Re: Docket No. 426; Third Taxing District, Proposed Fitch Street Substation

DOCKET NO. 426

THIRD TAXING DISTRICT RESPONSES TO CONNECTICUT SITING COUNCIL'S PRE-HEARING INTERROGATORIES

Fig 110-1
Safety Clearance to Electric Supply Station Fences

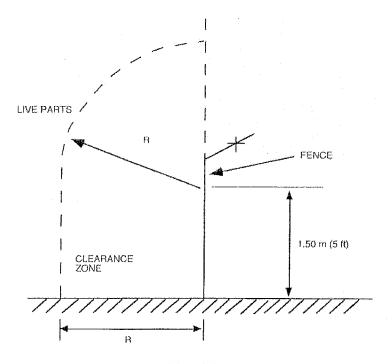
CSC-14. Are there minimum setback standards for the proposed substation components from perimeter fencing and adjacent structures? If so, does the site layout meet such standards?

Response: The NESC setback for 115kV construction is 13 feet and the proposed layout meets the standard. Please refer to the attached NESC sketch and table.

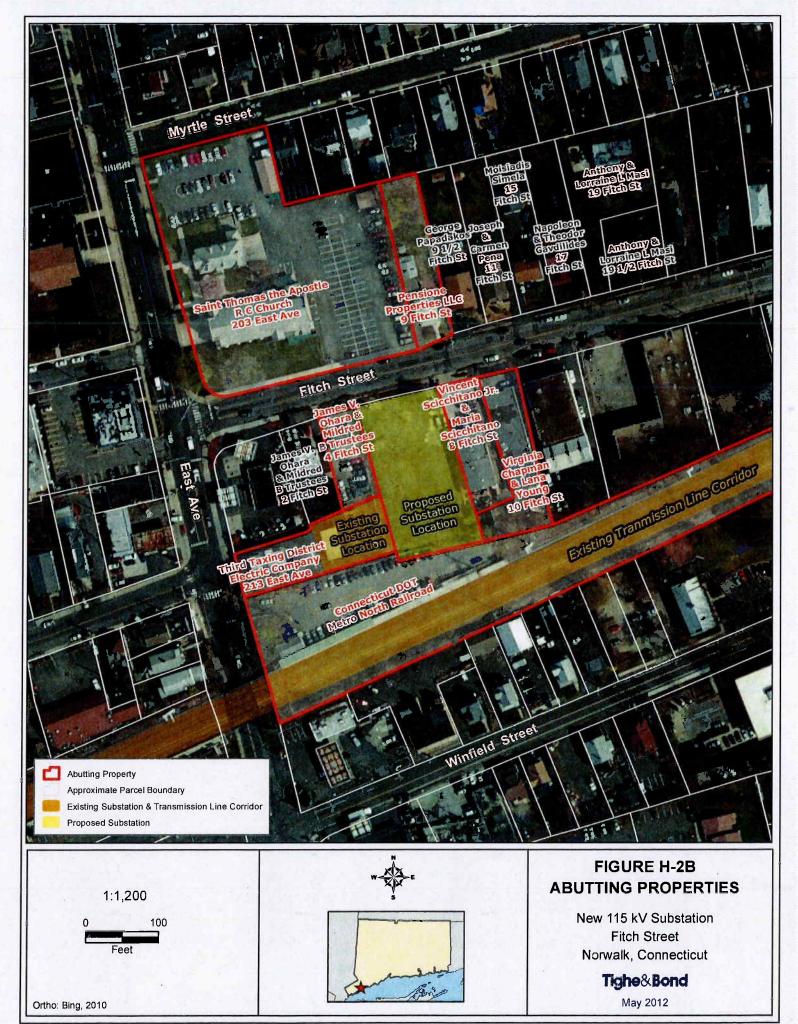
CSC-17. Provide a map showing the location of the abutting property owners.

Response: A map depicting the location of abutting property owners is depicted on figure H2-B, attached hereto. The owner information was obtained from the City Assessor's online database.
